# UNITED STATES PATENT AND TRADEMARK OFFICE

10/500,191

<b>Office Action Summary</b>	<b>Application No.</b> 10/500,191	<b>Applicant(s)</b> SANO, MASAHIRO	
	<b>Examiner</b> Geoffrey L. Knable	<b>Art Unit</b> 1791

(PRIOR ART)  
*Fig. 2*

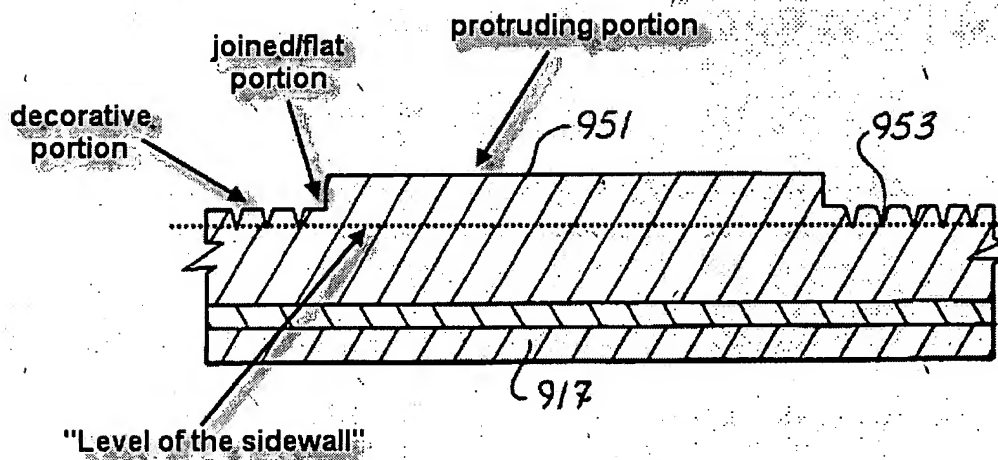
As to claim 1, Kemp et al. is applied for substantially the same reasons as set forth in the last office action. As to the new requirement that tops of the decorative portion protrude higher than a level of the sidewall, note the marked up figure 2 which has been further marked to show why this is still considered to be met:

Note that the tops of the decorative portion protrude higher than what is considered the level of the sidewall. A tire as required by claim 1 is therefore anticipated by this disclosure. As to the new requirement in claim 3 that the flat portions are provided between protruding portions, given that the tire includes multiple letters (which are the protruding portions - note fig. 1), the indicated flat portion would be located between protruding portions for areas between letters. A tire as required by claim 3 is therefore still considered to be anticipated by this disclosure as well. As to claims 9-12, note that the protruding portions comprise letters and the adjacent serrated portion does not comprise letters.

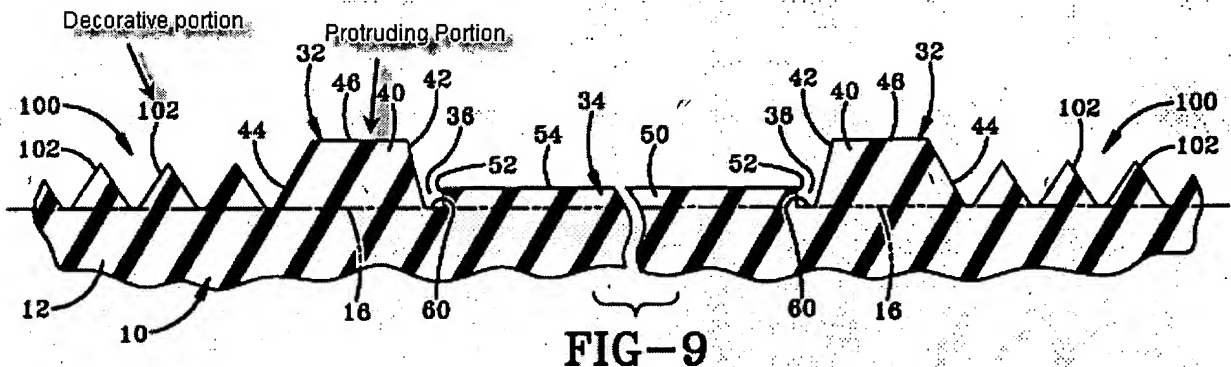
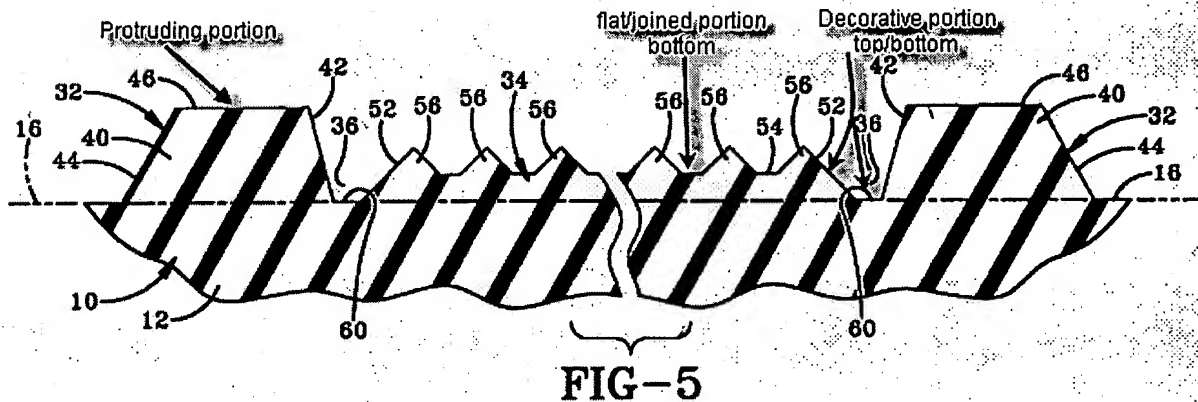
Vizina discloses a tire including a sidewall having a serrated background pattern (e.g. note various cross-sections) defining what is considered to be a decorative portion having interconnected tops and bottoms in the protruding direction; the bottoms of the serrations being reasonably considered a "level of the sidewall" from which the serrations protrude. Further, protruding portions higher than the tops of the decorative portions are provided in the pattern (esp. fig. 5) with a flat portion between adjacent protruding parts (i.e. the flat part between each of the two raised portions in fig. 5) being higher than the bottoms of the decorative portion (e.g. note again esp. fig. 5). This reference is therefore considered to anticipate what is defined in claim 3, the ambiguities already noted however preventing a complete and accurate comparison, any differences however being considered obvious optimizations of this basic teaching. As to claim 4, the parts between adjacent protruding parts are flat and can be said to

suggest or render obvious the claim 4 relative dimensions reading the dimension of the protruding ends as being from for example the outer ends thereof. As to claim 7, the illustrated relative dimensions are considered to suggest or certainly render obvious relative heights within the broadly claimed range, it being stressed that the illustrated design being a design patent would have been read to be a more accurate representation of how the final structure should be relatively configured. As to claims 11 and 12, note that the protruding portions define a group of letters "L" (fig. 2) while the serrated decorative portion does not comprise letters.
